SERVICE LETTER NUMBER 149

AIR TRACTOR LONG FINLET SUPPORT STRUT

By: MAB	Aircraft Makes/Model(s): AT-802A w/PT6A-67F (1600 HP) AT-802 (2-Place)	Float Model(s): 10000A	Note(s): Mandatory Compliance Service Letter P/N 1006743
Approved: SDW			
Date: 2/3/2021			
Rev: F

FIGURE 1

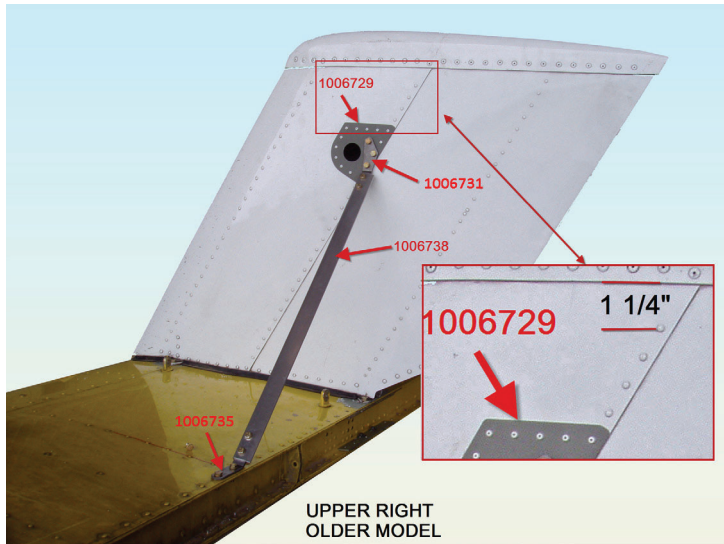
Aircraft serial number 189 or newer with newer model finlet (Figure 2) strut P/N 1006741	Aircraft serial number 188 or older with newer model finlet (Figure 2) strut P/N 1006751	Aircraft serial number 188 or older with older model finlet (Figure 1) strut P/N 1006738
Use KIT number 1006743-01	Use KIT number 1006743-02	Use KIT number 1006743-03

NOTE: See figures 1 and 2 to identify older model finlet versus newer model finlet

FIGURE 3

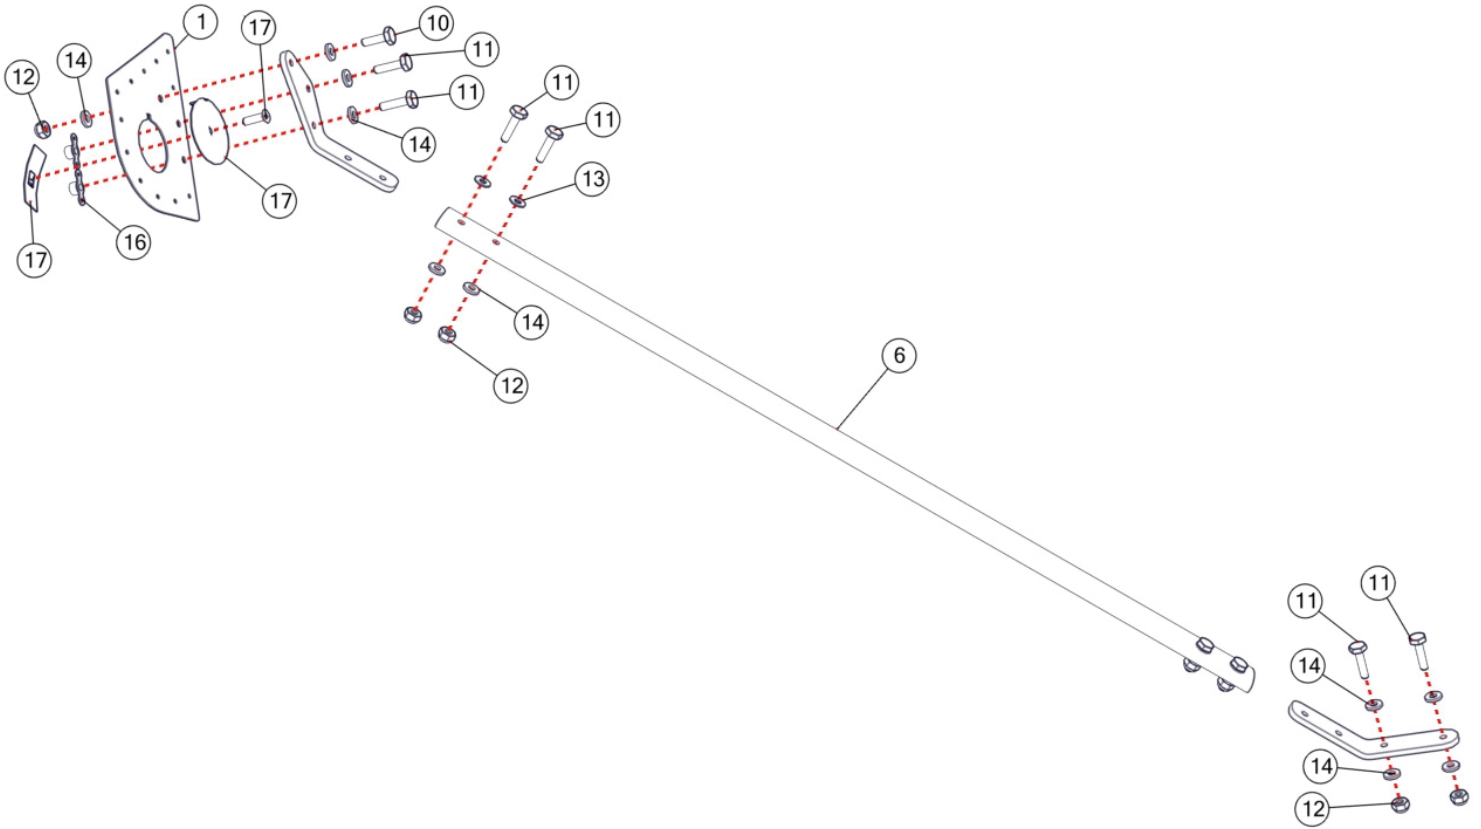
11. Open the 2 rivet holes in the horizontal tail plane to Ø.193" and deburr
12. Install the 1006732 upper fitting, 1006738/1006741/1006751 (see parts kit ID table for strut P/N) strut, and 1006737 lower fitting (use 1006740 alternate lower fitting if holes do not line align properly) as shown in figure 3. Coat all hardware with grease
13. Plug side not using strut fitting as shown in figure 4
14. Install 132641-5G access cover to each side
15. Repeat as required per aircraft configuration. Refer to table 1 for opposing part numbers

FIGURE 4

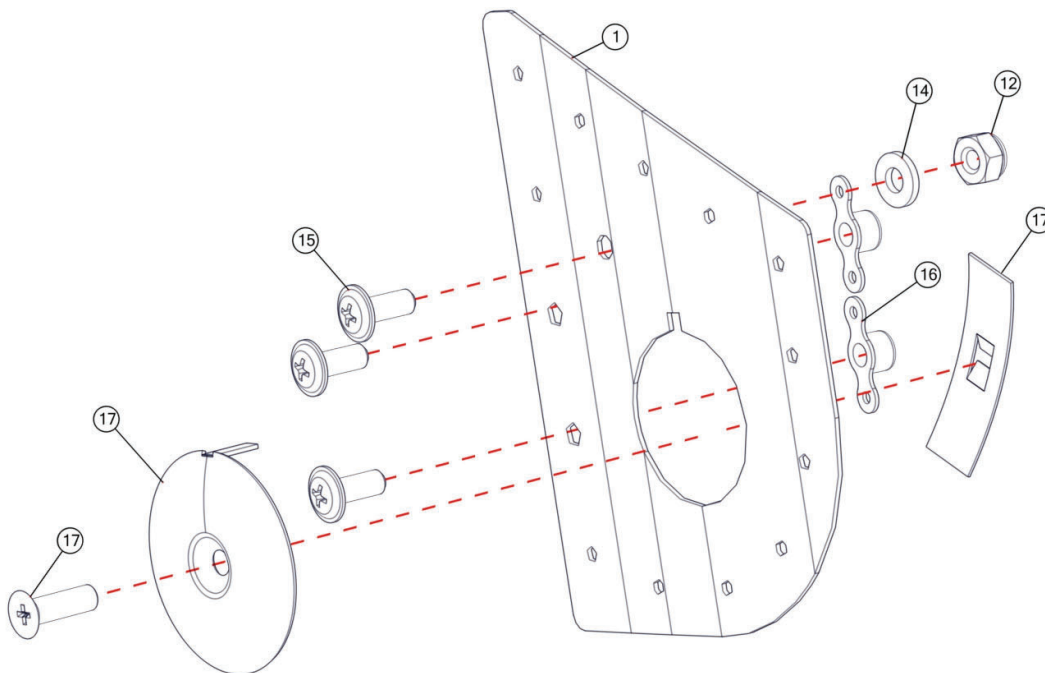
NOTE: To verify revision D or later has been accomplished, remove inspection cover (Figure 4, item 11 of this service letter) to visually verify if 1008671 internal doubler has been installed.
